RECEIPT DATE: 3-17-25 **ONSITE SEWAGE DISPOSAL SYSTEM** P 587984

APPROVAL DATE: 3/27/2025 **PERMIT:** Tank UPGRADE
Replacement A _____

PROPERTY ADDRESS: 1020 Sunset Valley Drive

Onsite Sewage Disposal System Design Plan

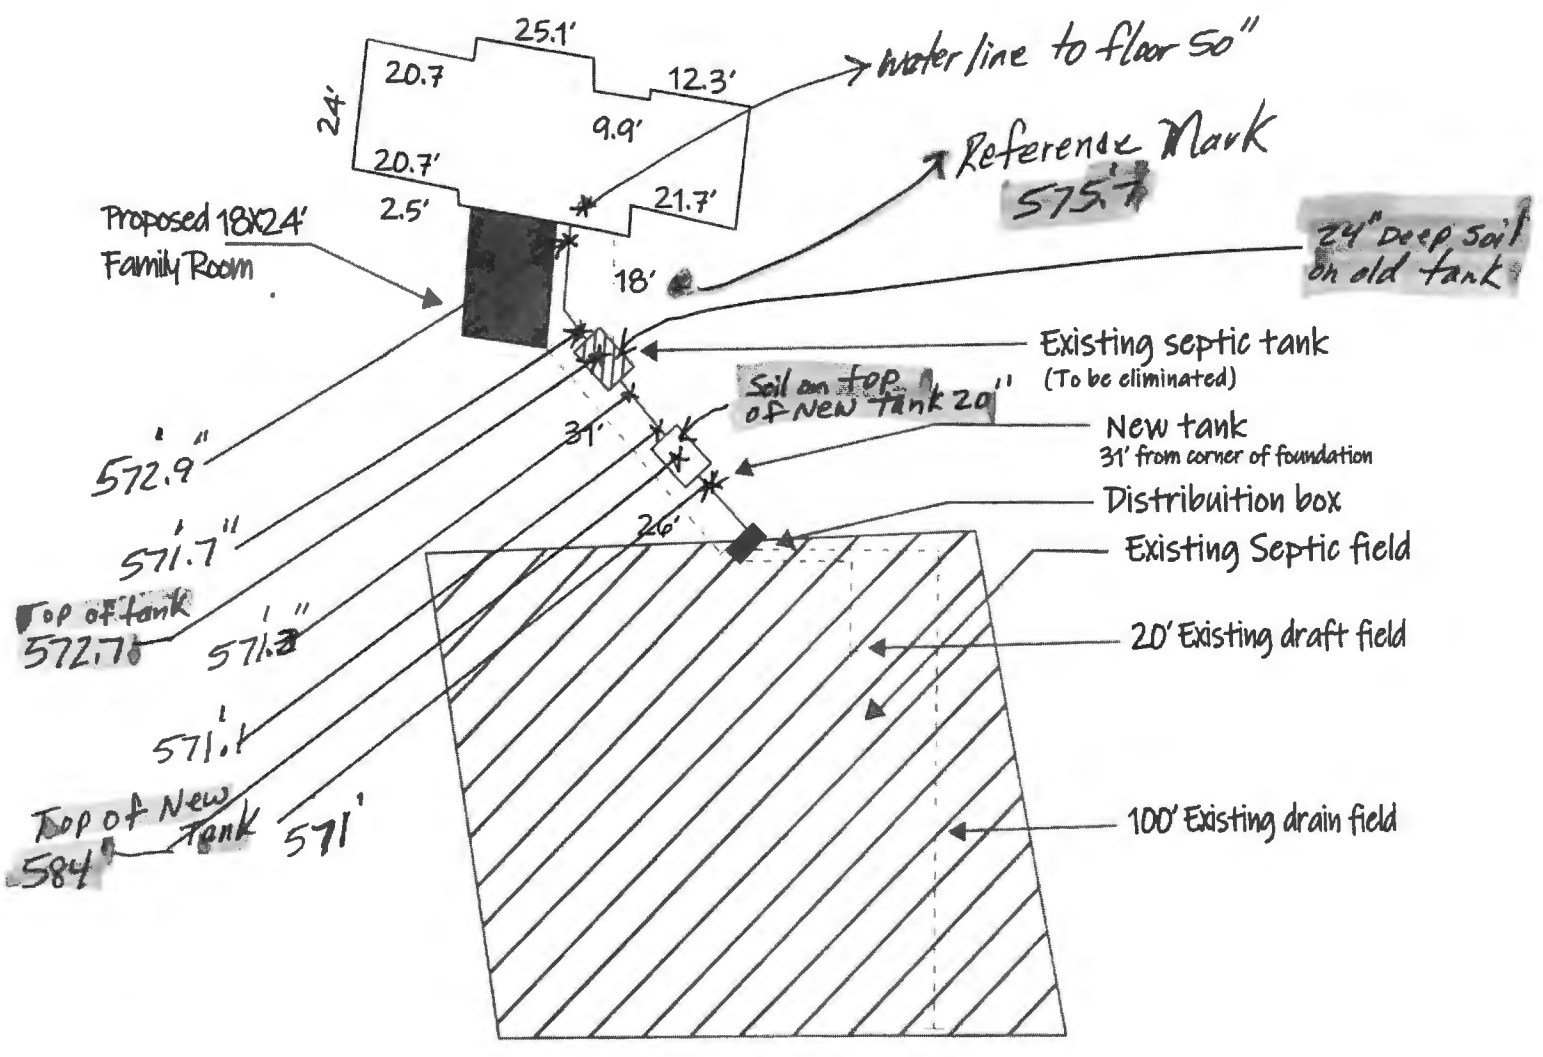
Per our last discussion. You had requested the elevation at the entry point of the distribution box (569'.8") also the depth of soil at the old tank 24" and the depth of soil at the new tank 20" and the elevation 572'.1"

We have the main house sewer pipe exiting the house at 572'.9" and a distance to the distribution tank of 74' linear feet and entering the pipe at 569'.8". This gives us an invert or drop of 37" over the 74'. This was your concern. If you calculated a minimum of 1/4" (.250) x 74 linear foot that gives us 18 1/2" and we have 33". I believe we have more than enough drop based on standard guidelines. But of course this is for your department to determine.

As mentioned all of the 4" pipe from exiting the home to the distribution tank will be changed to standard PVC pipe and removing the old thin wall PVC that currently exists. This also allows up to ensure even and consistent drop from the house to the new tank and from the new tank to the distribution tank.

I wanted to ensure you received the information that we spoke about yesterday and to clarify some details discussed regarding the elevations on the plan. First I have provided the link for the HC GIS and the reference datum is NAD83 (North American Datum of 1983). See the link for access @ <https://data.howardcountymd.gov/InteractiveMap.html> and I have provided the maps to more accurately reflect the contour lines for your property (see attached). In regard to the plan that provided the elevations, I pulled the record file for your property and the plan with the elevations was a design plan, but the septic tank elevations are based off of that and not where the tank was installed in the field as

you have shown on your sketch plan as well as our as-built sketch. As previously mentioned the invert elevations will need to be provided for both the existing tank and new tank location as well as the depths of the tanks. Our inspection supervisor stated he is fine with the contour data shown even though it doesn't show a true representation of the property topography. In other words, there is no need to worry about revising the topographic lines. As for the new tank location this has a **20'** setback to your proposed addition and does not need to be 30' away as currently shown. If the septic contractor believes that the new tank location should be closer than the 30' shown than you can get as close as 20' away to the proposed addition. Kevin spoke to your contractor Ken Schisler this morning to relay the elevation information we need to complete our review and hopefully have this plan approved soon. Please work with your licensed septic contractor to get us the information needed for the new septic tank installation. Please let me know if you have any other questions and thank you kindly.

TRENCHES:	LINEAR FEET REQUIRED: _____	INLET DEPTH: _____
	TRENCH WIDTH: _____	MAXIMUM BOTTOM DEPTH: _____
	MINIMUM SPACE BETWEEN TRENCHES: _____	EFFECTIVE AREA BEGINNING DEPTH: _____
LOCATION:		
NOTES:	Septic tank to existing sewer line. Septic tank will be less than 3' cover and at least 1% fall throughout.

Hello. I reviewed the plan and approved. In review, this is not the easiest plan to understand. The latest version you emailed me with all the elevations listed on it is enough to approve, but previous versions were missing that. For future reference, we have an OSDS plan guidance document on our website that can help plan preparers provide a plan to us that has all the components we need for approval.
